Crown Pastoral Land Tenure Review

Lease name: Allandale / Greenvale

Final Report on Public Submissions

FINAL ANALYSIS OF PUBLIC SUBMISSIONS ON PRELIMINARY PROPOSAL

Figure 2. Public access routes to proposed conservation land in Roberts Creek (red), showing proposed Conservation area (edged pink) and proposed freehold (edged green). Conservation management access is proposed along track c-d, and farm access along d-f.

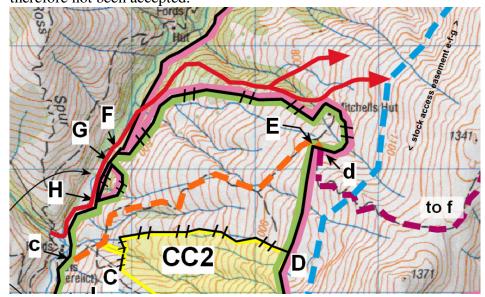
Point	Summary of Point Raised	Submission Numbers.	Allow or disallow	Accept or Not Accept
5	Public access should be provided across the proposed freehold on the existing track from near Robert Creek up to point 'f' or to Mitchells hut near point 'F'.	2, 5, 8	Allow	Not Accept

The track is across proposed freehold. Submitter 2 sought to enable recreational hunters to transport harvested wild animals out from the new conservation area using vehicular access, up to point 'f' and beyond. The route beyond point 'f' is covered in point 6.

Submitters 5 and 8 suggested that public access should be provided up the same route except that they suggest it should go to Mitchells hut near point 'F'. These submitters suggested that accessing the new conservation land from Robert Creek would otherwise be a difficult proposition. Submitter 8 suggested a foot access easement, and it appeared that submitter 5 was also not necessarily proposing public motorised vehicle access.

The whole issue of public access to the proposed conservation land up the Roberts Creek valley was reviewed. The use of the track indicated was considered to be unattractive from a public use perspective, since it traverses through highly modified farm country, would inevitably require track closures related to farm activity, and would be likely to result in ongoing tensions between the farming activity and public use. The track was also not seen as being of a sufficient standard to warrant general 4 wheel drive public access, and to upgrade it and maintain it for such use would not be warranted. Good alternative public foot access was identified using Roberts Creek riverbed

and marginal strip, then passing directly into the conservation land. Once in the conservation land, direct and practical access to the higher country is then available up the existing cleared fenceline which will become the conservation boundary. This situation is displayed in Figure 2. The point has therefore not been accepted.

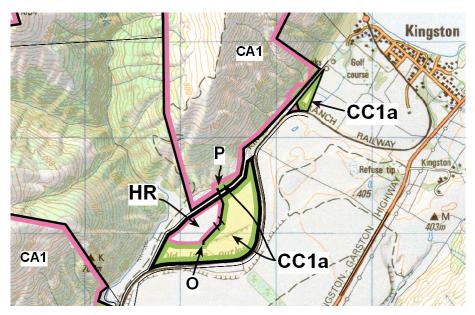
Poir	Summary of Point Raised	Submission Numbers.	Allow or disallow	Accept or Not Accept
20	The middle area of CC1a has significant inherent values that may not be adequately protected under the proposed covenant.	8, 9, 11, 12, 13	Allow	Accept in part

Submitter 8 stated that central part of CC1a had a good cover of short tussock with a dominance of native inter-tussock herbs, and also matagouri, and that these values may not be adequately protected if grazing was allowed to continue.

Submitters 9 and 13 also indicated the occurrence of a valuable remnant of short tussock grassland in the area and suggested the covenant should only allow light sheep grazing, to control rank grass growth and weeds, in favour of short tussock. Submitter 11 held the same view, if protection of the area was to be by covenant.

Submitter 11 considered that this area, containing short tussock grassland, should be retained in the conservation area, given that it is would be enjoyed at close quarters by the public, and in view of the contribution it makes to the landscape and ecology of the area. The amended designation plan attached to the submission also suggested a small isolated area which has native shrubland in the northernmost piece of CC1a should be included in the conservation area.

Submitter 12 noted that the central area of CC1a contained representative short tussock grassland, and that it was a land environment that is acutely or chronically threatened. They also considered that the area would be viewable at close quarters by the public, and that there was a need for public access through the area. This submitter believed that the area should be retained in the conservation area. The submitter argued that if light grazing was required for grassland restoration, this should be carried out under Department of Conservation management, where restoration could be the goal, rather than economic return.

This issue has required more review and consultation than any other point in submissions. The main upper terrace area has been confirmed to be classified as "acutely threatened" and the land below the terrace as "chronically threatened" at LENZ level IV. Indeed, the main LENZ unit (N3.1a) only has 2.9% of that unit still with indigenous vegetation nationally, and that percentage has been shown to be decreasing since 1997, and only 0.5% of the unit is protected. The area was ground inspected in detail and confirmed to have predominantly indigenous vegetation cover composed of hard tussock and shrublands. Gorse and exotic broom are beginning to become a threat to this area, and accidental fires from the Kingston Flyer railway line, which forms the eastern border, continue to compromise values along that margin. Given the LENZ classification, particularly the upper terrace, and the indigenous vegetation cover, the site achieves the highest level of significance in the Department of Conservation's criteria for defining significant inherent values.

The appropriate tenure was considered. Full Crown ownership and control could be justified for this site, but there was great difficulty in achieving this over the whole area, since the area is an integral part of the lowland farm operation. Although not cultivated, the well drained rocky nature of the terrace makes it a valuable grazing site during wet periods. The possibility of multi-use via a covenant was explored, however the Holders expectations of being able to graze cattle conflicted with the conservation objectives of enabling restoration of the vegetation, including the regeneration of shrubland species. Ultimately it was determined that the issue could not be resolved through a multi-use covenant, and the matter was resolved through a split of the area into land to be retained by the Crown for conservation as historic reserve, and land to be freeholded unrestricted by any requirement to manage the grazing of the site for vegetation restoration. The solution arrived at will see the Crown retention of the acutely threatened land that adjoins other land that is already reserve or proposed Conservation area. An added benefit of this solution will be that the area of Crown retention will encompass the sites of historic and archaeological value on this terrace. This solution also makes a practical boundary for the land being freeholded, where landform and landscape protection will still be provided by covenant CC1a.

The proposed outcome will ensure the protection of some of this area. The Department of Conservation consider that the area being retained is of sufficient size to be viable in the long term. However, protection is not being proposed over the entire terrace as suggested by some submitters. The point has therefore been accepted in part.

Figure 4. Additional forest remnants near Roberts Creek to be retained as conservation area (CA2).

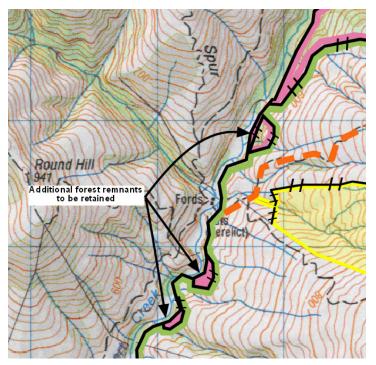
Point	Summary of Point Raised	Submission Numbers.	Allow or disallow	Accept or Not Accept
22	Conservation area CA should be extended along Roberts Creek, south-west from point 'E', to include all remaining riparian beech.	9, 11, 12, 13	Allow	Accept

The submitters identified that there was beech forest along the margins of Robert Creek, south-west from point 'E' (point 'F' in SP). They submitted that this area should be fenced and included in the area CA. They stated that some of this has recently been burnt, but would have the potential to recover if grazing was excluded.

This area was reinspected, and a number of additional small enclaves of beech forest were found at the foot of the Robert Creek slopes, and it has been agreed that any notable such forest areas will be retained as Conservation area. Three such areas were identified and have been added to the land to be retained in full Crown ownership and control. The point has therefore been accepted.
